APPLICATION FOR PERMIT TO DRILL, DEEPEN, OR PLUG BACK

SURVEY PLAT FOR  
H. MOORE-OLD WOMAN #1 WELL  
NE.SW.SEC.2-23S-4E  
SEVIER COUNTY, UTAH

SURFACE USE AND OPERATIONS PLAN  
FOR  
J. HIRAM MOORE-OLD WOMAN #1  
NE.SW.SEC.2-23S-4E  
SEVIER COUNTY, UTAH

WELL CONTROL EQUIPMENT FOR  
J. Hiram Moore Old Woman #1 Well  
Sevier County, Utah

Well: Old Woman #1

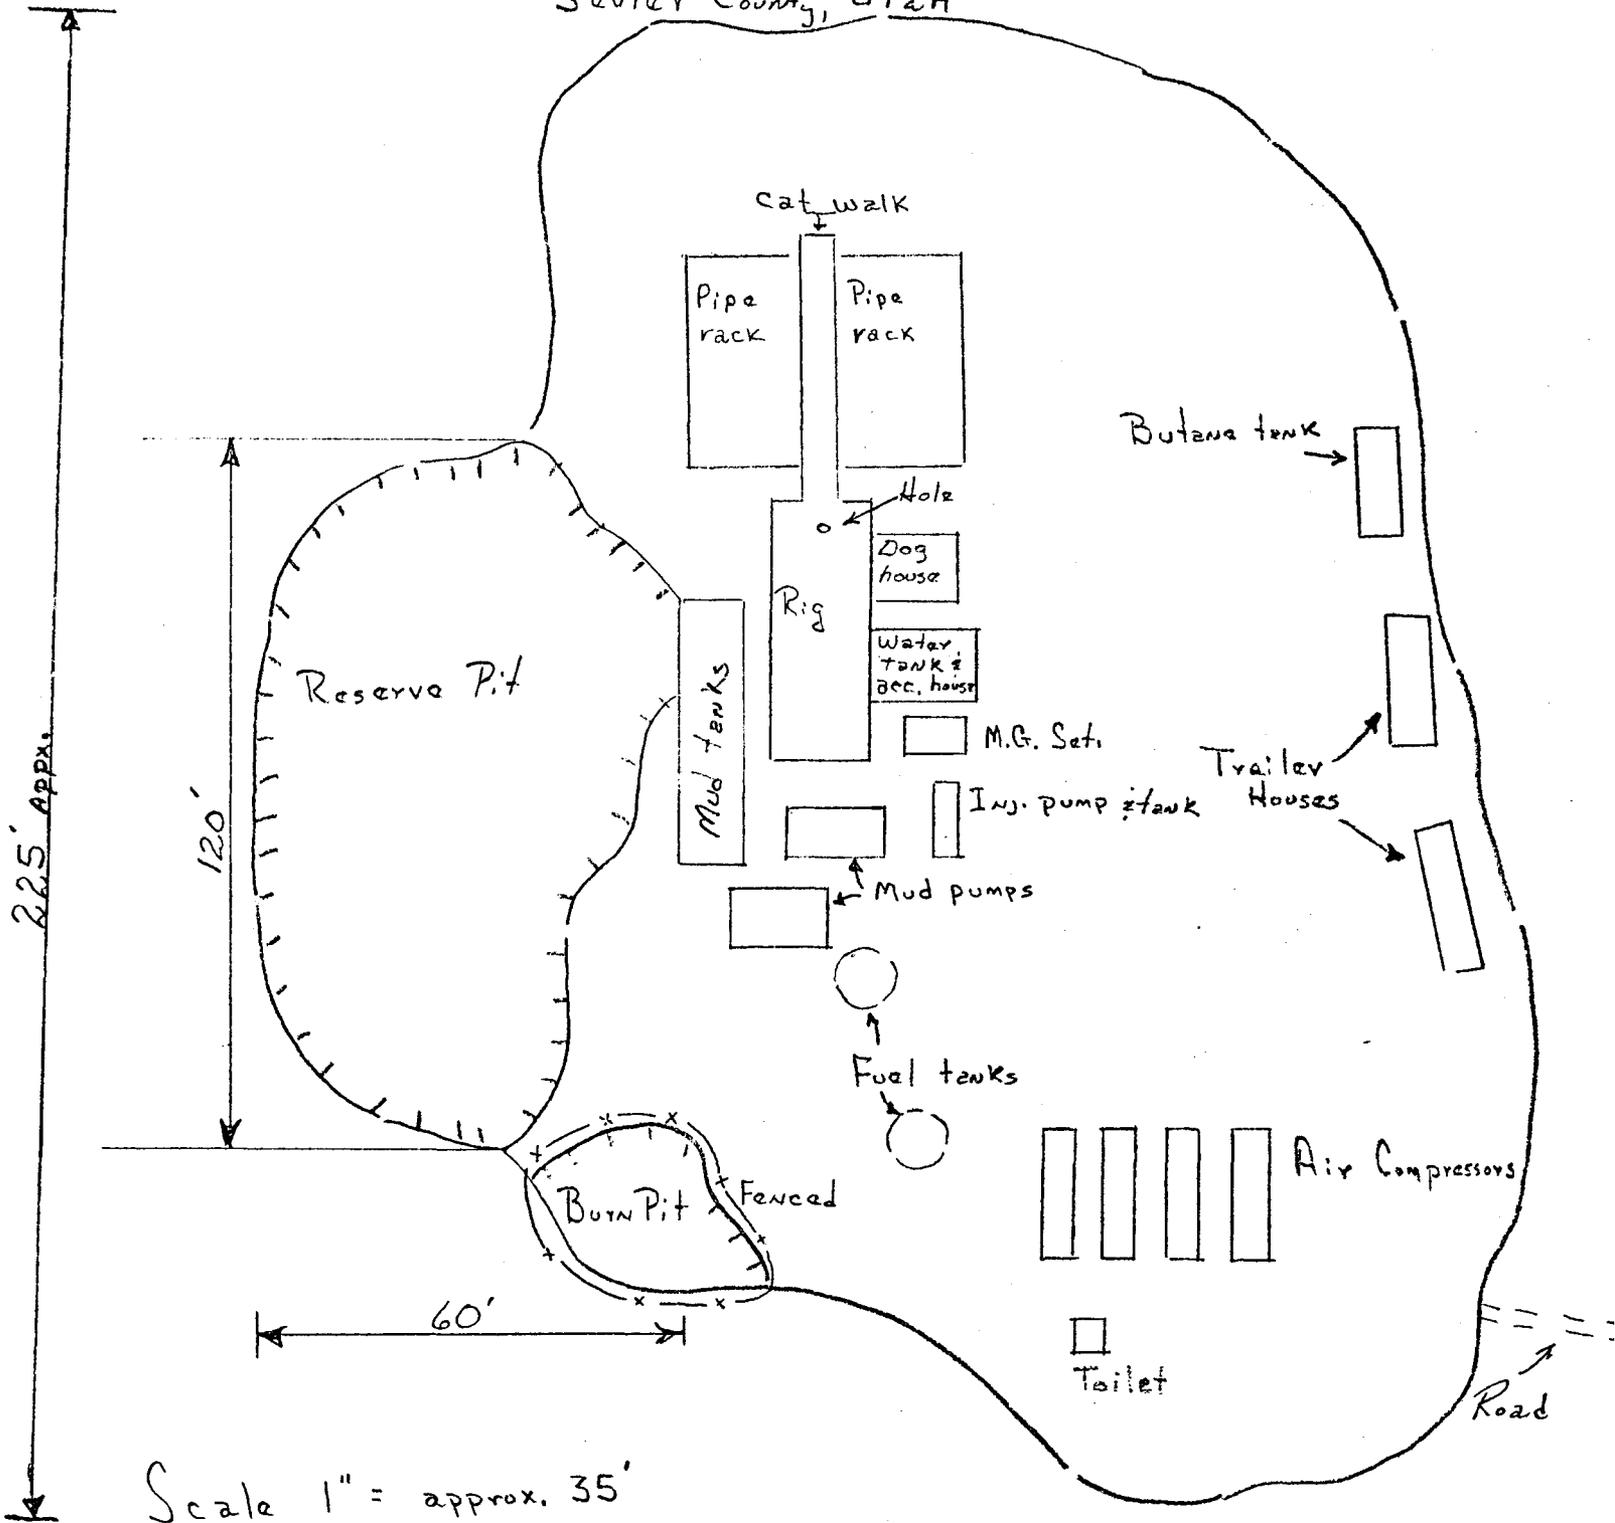
An intensive archaeological survey was conducted by zig-zagging across the entire flagged drill pad area. No cultural resources were observed in the proposed impact area. In the event that sub-surface cultural resources are discovered by construction, a qualified archaeologist should be consulted.

Clearance Status: Recommended.

Because no cultural materials were discovered in the proposed impact area, it is recommended that Hyrum Moore Co. be granted cultural resource clearance for this construction work.
